November 5, 2002

**Subject: Eastern Michaud Flats Superfund Site – Groundwater Extraction
System Design Meeting Follow Up**

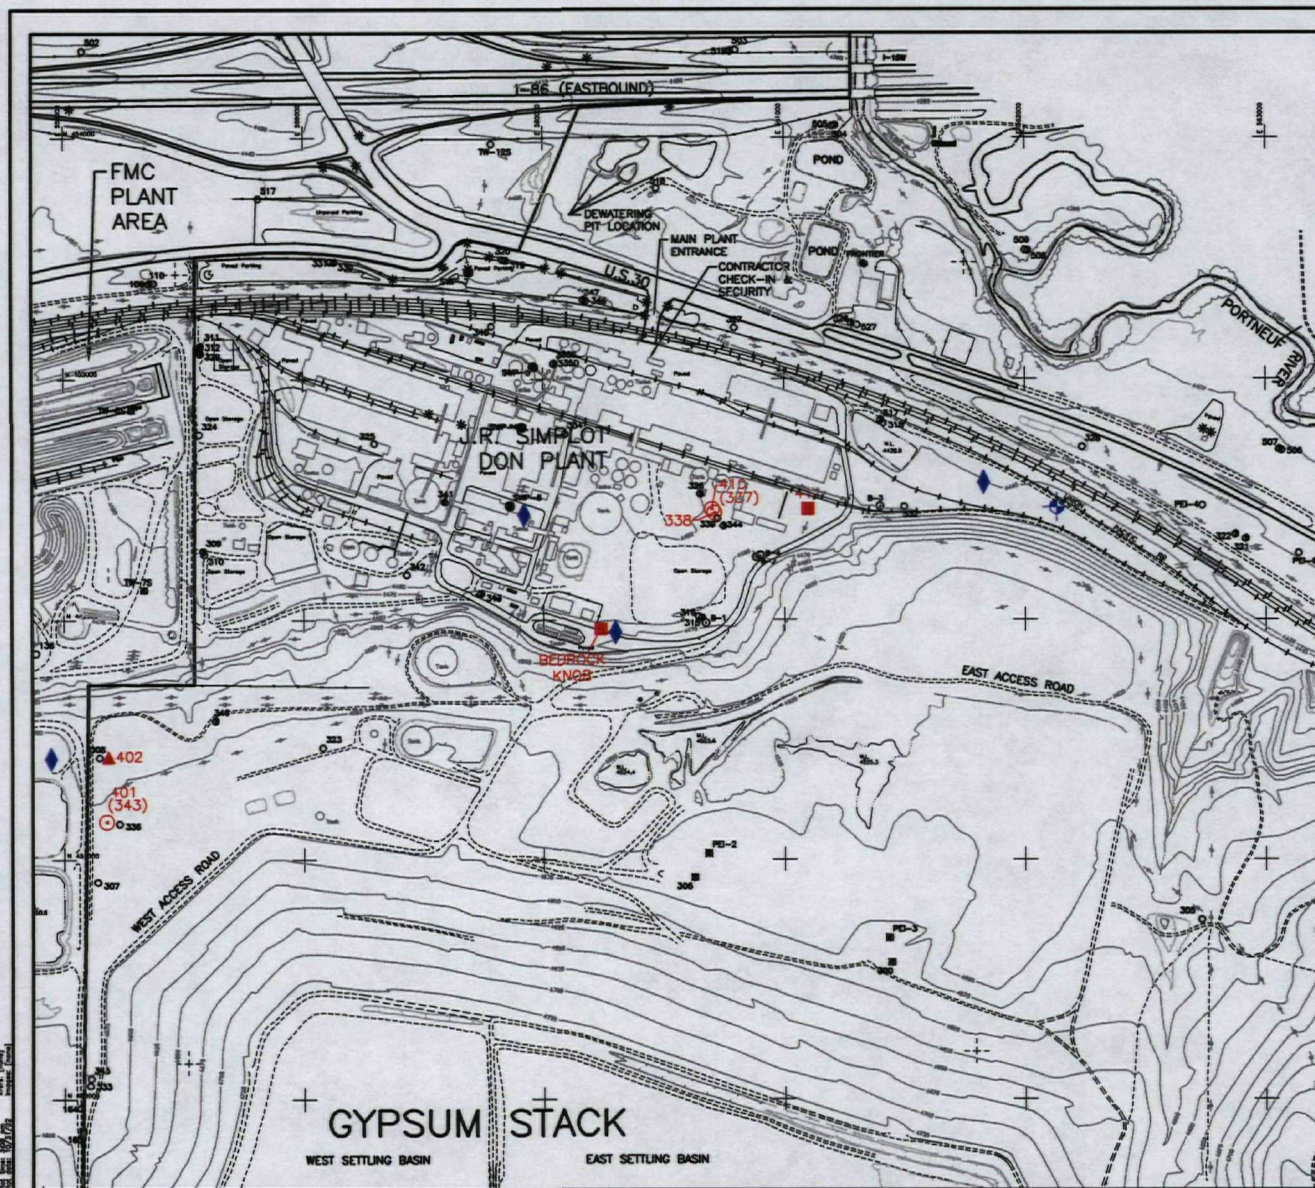
- 3) Simplot will contact FMC to obtain approval to install a piezometer into the first saturated zone on FMC property approximately 200 feet west-northwest of well 308 for use in preparing more accurate potentiometric maps and to monitor water levels during the 402 pumping test (see attached map for proposed location). Simplot will perform the work if granted access by FMC.

- 1) Simplot will complete the field work set out in the work plan for well inspection, testing and installation program, submitted to the Agencies in mid-September.
- 2) Simplot will install wells (one shallow and one deep) in the area east of well 332 to obtain water level and water quality data for these zones downgradient of the eastern

part of the lower gypsum stack (see attached map for proposed locations).
